Appeal NO: ABP 314485

Bord Pleanála Case Number: ABP-314485-22

Planning Authority Case Reference: F20A/0668

Observations relating to Bord Pleanála Case reference ABP-314485-22 subsequent to the receipt of additional information from daa.

Figure 1 The present EIAR claims the coloured area as the "permitted" scenario.

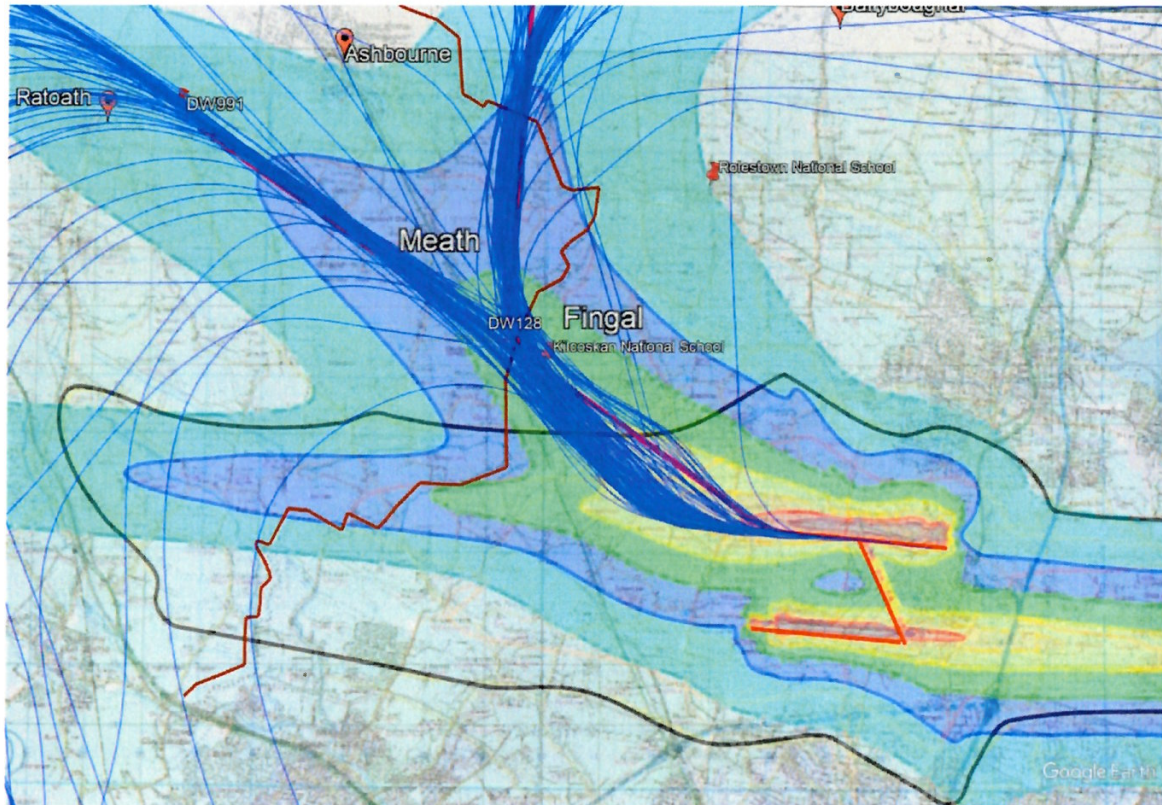
ADSB transponder data captured from aircraft departing DUB over a 16 hour period was used to show the paths actually flown. Note about 50% fly directly over 12,000 people in Ratoath and 100% fly within 2km of Ashbourne while at climb power, the noisiest most disruptive phase of flight.

In Figure 1, daa's Forecast Lday Noise Contours 2035 Permitted Scenario Figure 13C-23 are overlaid with the current traffic. The magenta tracks currently in use form the 4th flight-path design so far by daa/AirNav and only went into operation in February of 2023.

Examination of the original EIS (*shown with a black outline*) demonstrates that the Noise Contours in Figure 1 are nowhere near the noise contours claimed as permitted in the current EIAR. Simple logic dictates that it is impossible that these noise contours are the "Permitted Scenario".

Note that every departure overflies Kilcoshan Nation School near the Coolquay.

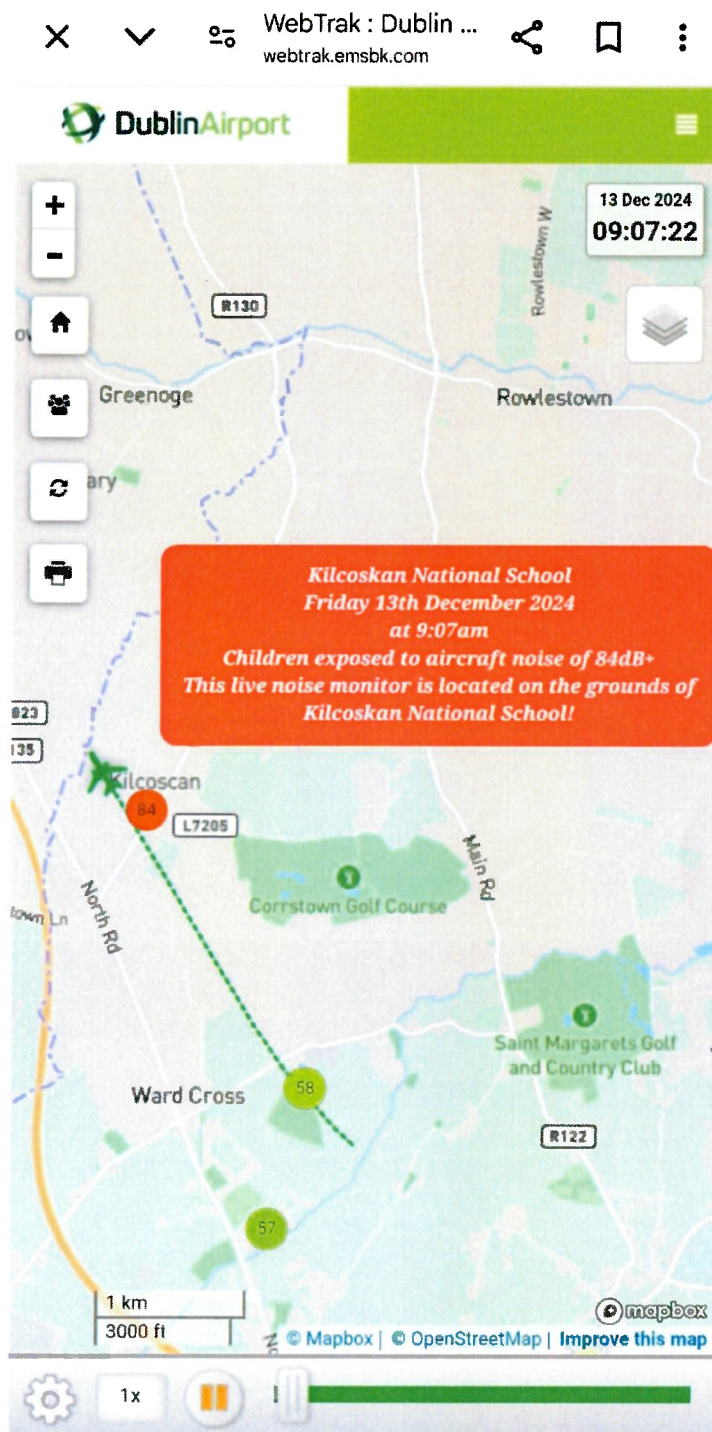
This in effect is a new application for new flight paths with new noise impacts.

This is a screenshot taken from the DAA's own Webtrack showing 84 Db of a departing aircraft. This area is outside the only planning permission granted for the North Runway in 2007.

Figure 2 New submission from daa further clarifying breach of Condition 1 of the granted permission

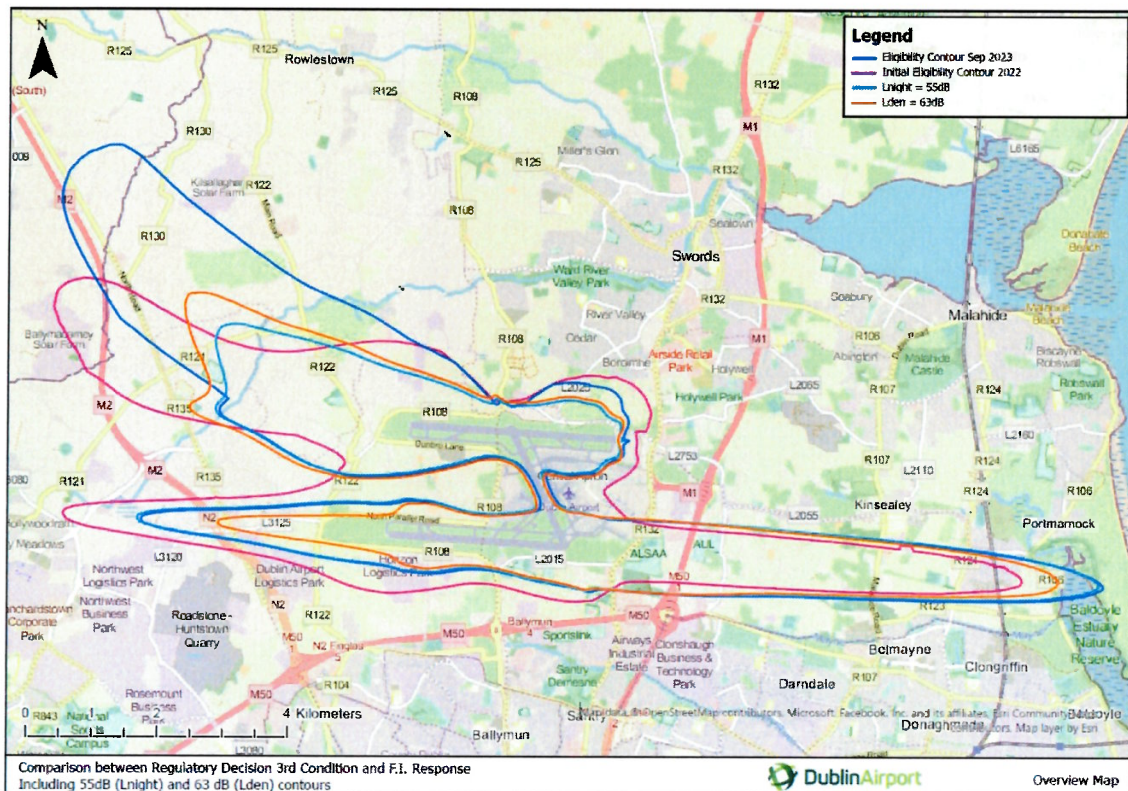
Figure 2 supplied by daa shows that the RWY28R SID is in clear breach of Condition 1 of the granted permission.

Figure 3 Latest ANCA data demonstrating noise all the way up to Ashbourne and Ratoath

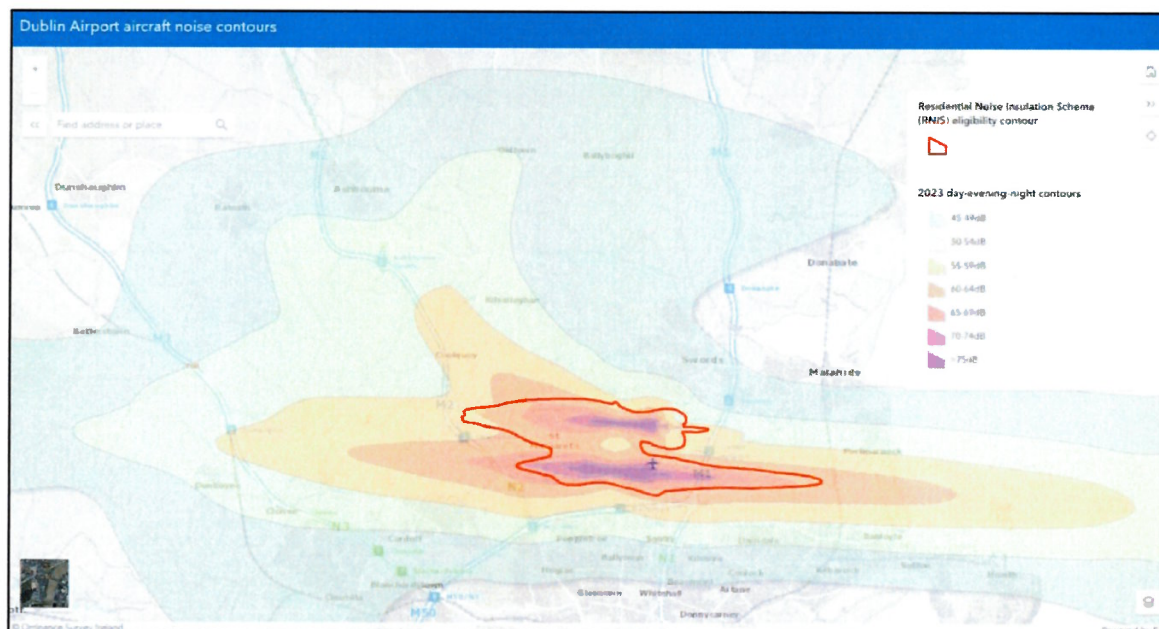
Once again, daa's new submission demonstrates their casual disregard for condition 1 of the only planning permission in force for the north runway.

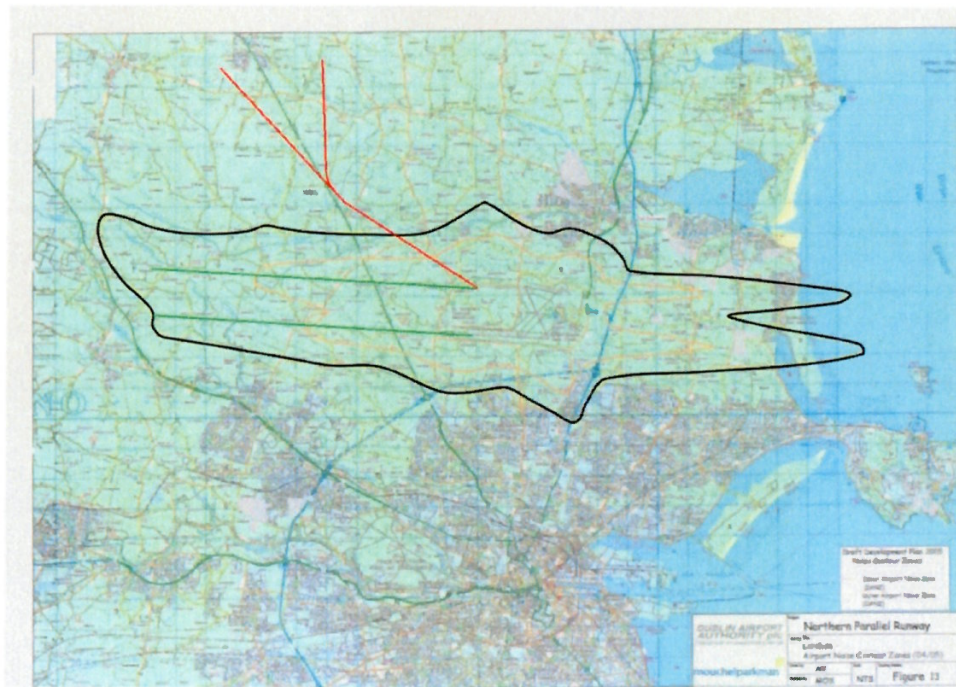
This Chart shows the outline of the 2007 planning permission, with green lines indicating the intended flight paths, and the red the actual flown illegal flight paths.

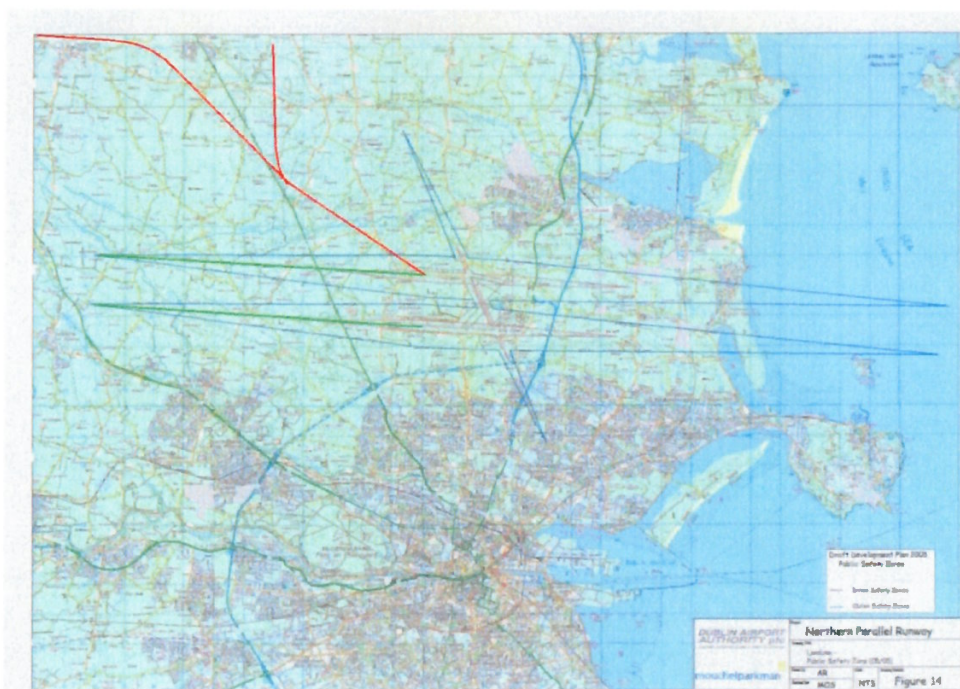
This chart shows the Public safety zones as part of the 2007 planning permission. In red the actual illegal flight paths.

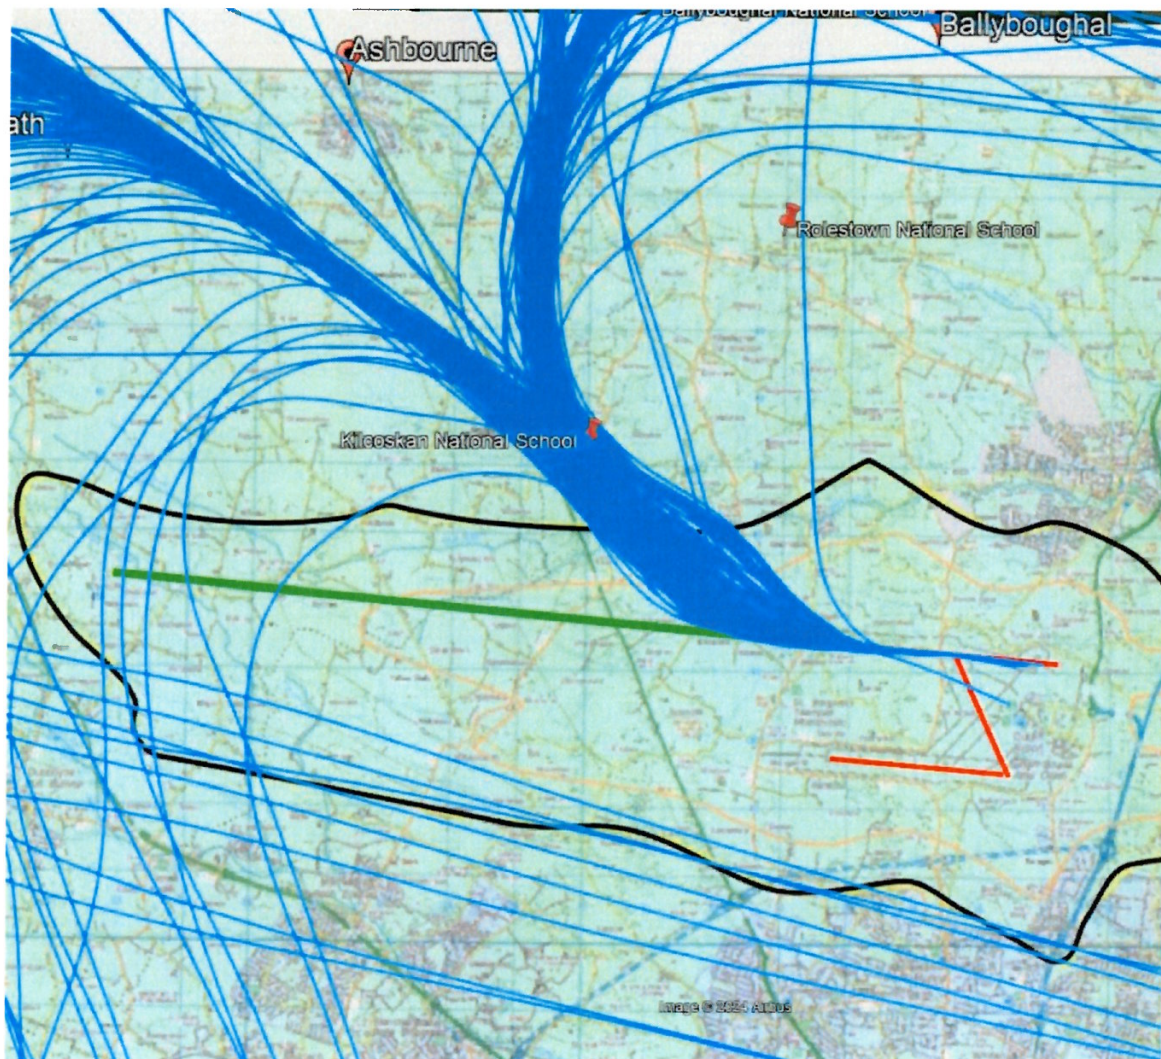
Here is a 16 hour period of flight paths, with the Black outline showing the only approved planning permission EIS, with the green proposed flight path used for that planning application.

Because the aircraft have to make so many turns their ability to climb is reduced significantly, and therefore the noise impacts of departure tracks with large turns compared to straight departures is compounded, with aircraft flying lower for longer periods creating more noise.

This combined with ATC instructing aircraft to turn off the departure tracks and increase speed at low levels, again increases the noise impacts even further.

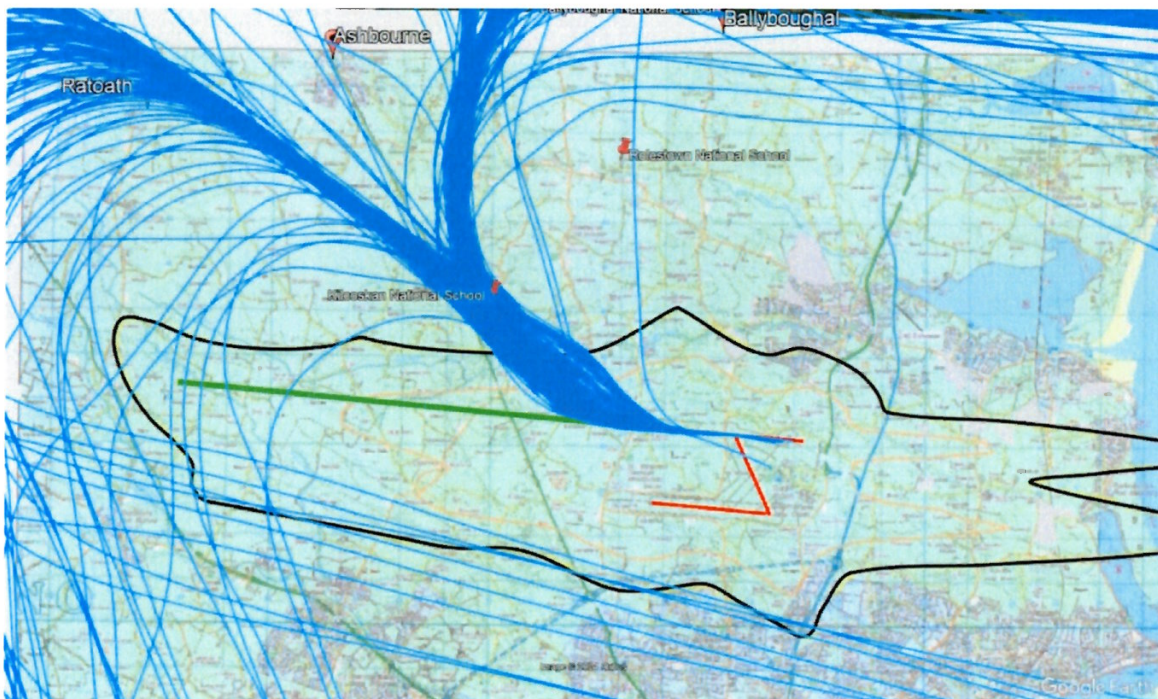
This chart shows the outline in black of the 2007 EIS provided by the DAA to ABP seeking planning permission for the north runway. The Blue lines are one period from 0700-2300, actual flight track data.

This chart clearly shows that the departures are not in line with the planning permission of the noise preferential route in green, which was issued by the DAA to ABP in 2006.

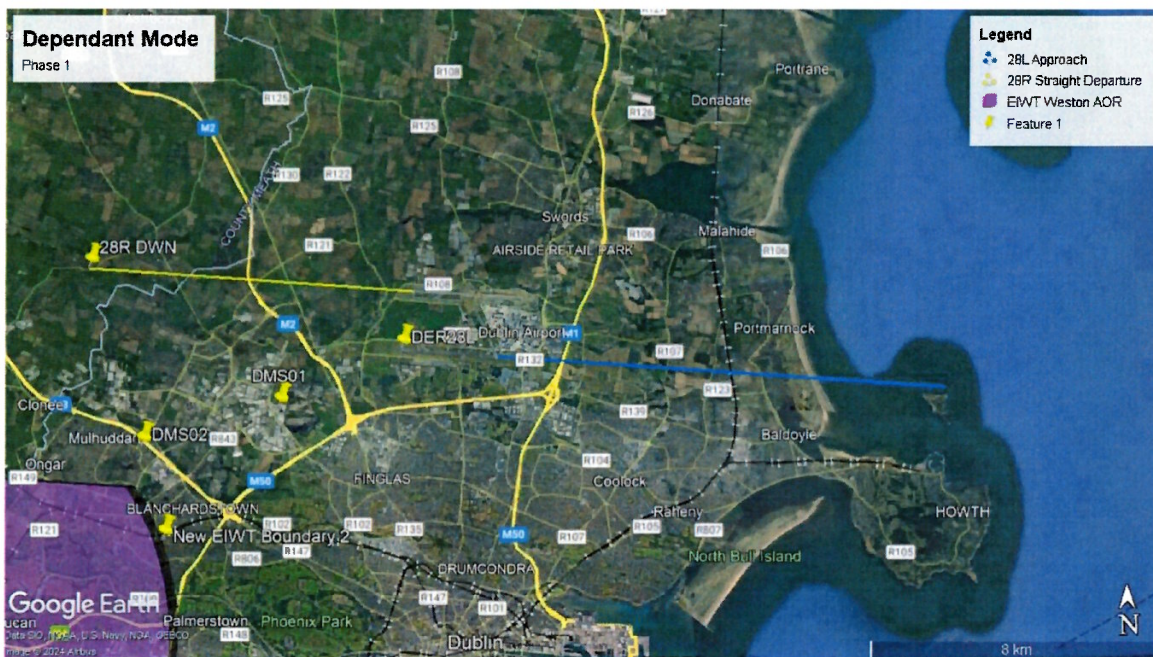
Aim: To have 28R departures straight,

Issue a Trigger NOTAM (Notice to Airmen)

All CAT C and CAT D Standard Instrument Departures off 28R Suspended.

New 28R Procedure. Climb Straight ahead to EBEZA CLIMB FL90 CONTACT DEPARTURE
FREQ. Expect Radar vectors or direct routing to FLIGHTPLAN.

28L MISAP CLIMB STRAIGHT AHEAD TO GANET CONTACT ATC CLIMB 3000FT.

**LOSS OF COMMS MISAP 28L CLIMB TO GANET 3000ft THEN CLIMB 5000ft and TURN LEFT
TO UMOWI. COMPLETE ONE HOLD THEN MAKE AN APPROACH TO LAND 28L.**

Dublin ATC would operate DEPENDANT MODE. EG 28R Departure would be given clearance
when the 28L aircraft Lands. This will not slow down arrival or departure flow rates from currently
achieved rates. There are currently 3-4 arrivals each morning between 0600-0700, the peak wave.

Yellow line is straight departure off 28R, Blue line is Approach 28L.

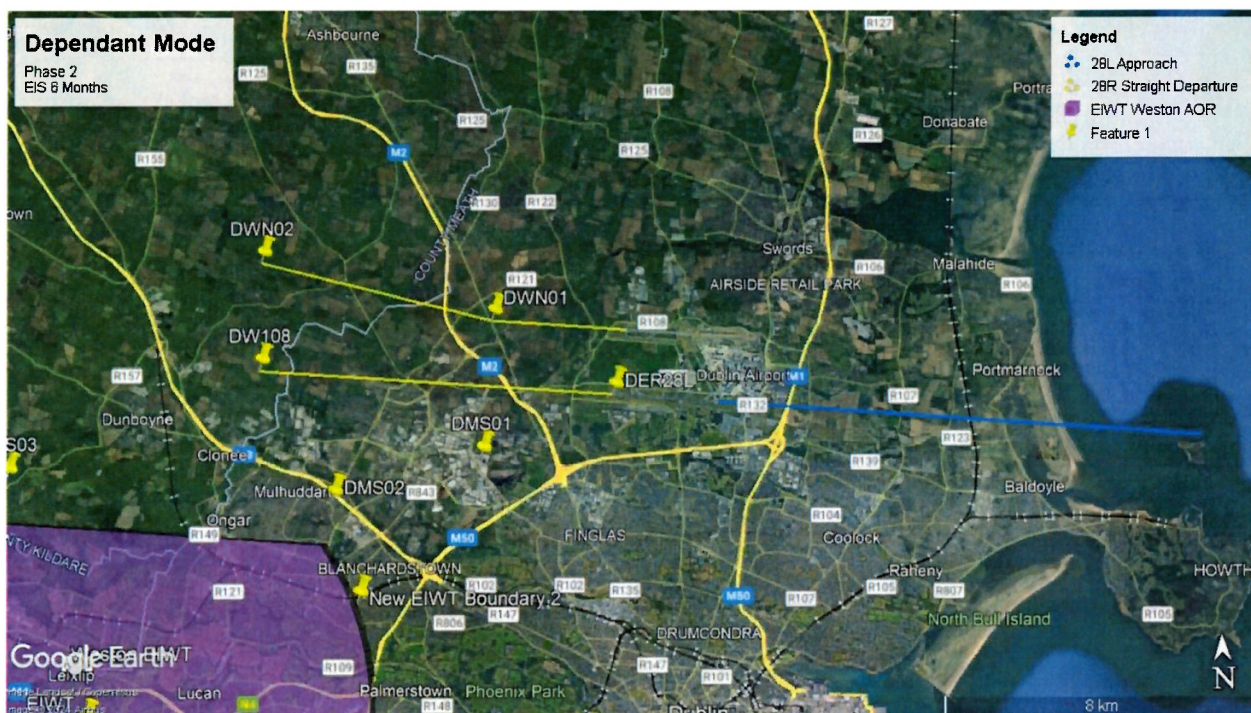
Aim: To have both runways departing aircraft simultaneously.

The yellow lines are departure tracks, with a 10 degree divergence within 2 nautical miles. The blue line is the arrival path.

DWN01 Is end of runway 28R 1.9 NM

DWN 02 is a track 10 degrees right after DWN01 to the same distance as GANET on the south runway.

Pic: Example of a new missed approach design

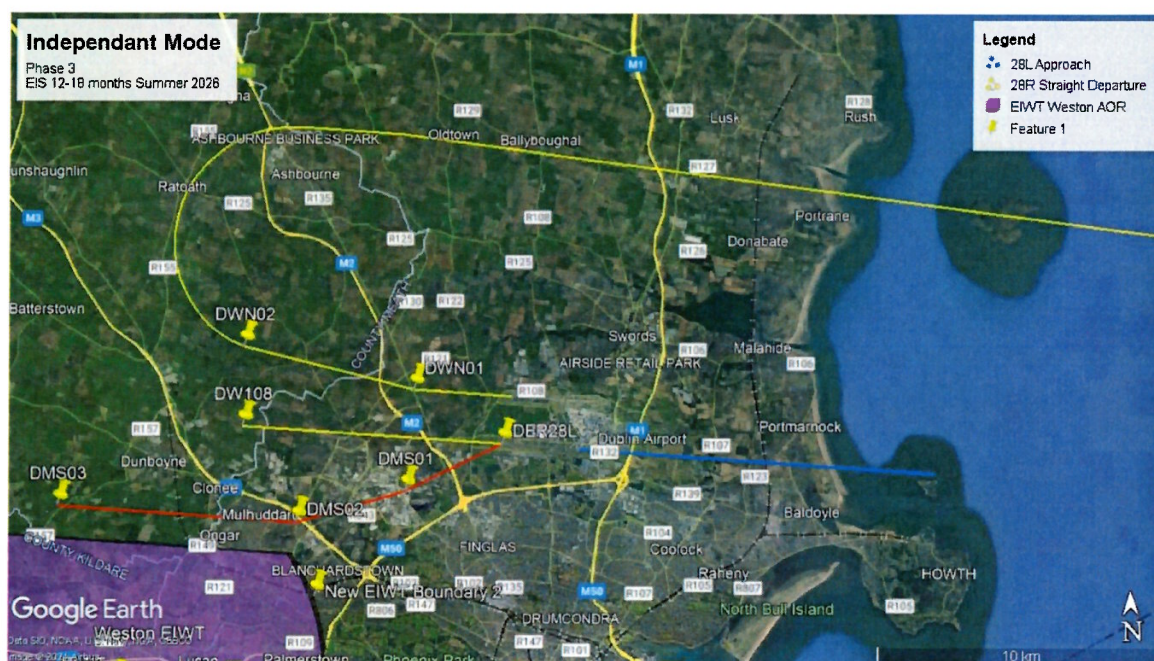
Once this phase is operational, the DAA and ASAP will have time to design a new missed approach off 28L, which would allow fully independent operations, Phase 3.

Yellow lines : Departure tracks

Blue line : Approach 28L

Red Line: New missed approach 28L with required ICAO DOC 9643 regulations complied with.

This phase 3 allows fully independent operations, the maximum capacity that is possible at Dublin Airport

This new missed approach is an example of a solution. 30 degrees deviation is guaranteed until 3NM radar separation is achieved, and the aircraft are always deviating away from each other initially by track, then by altitude.
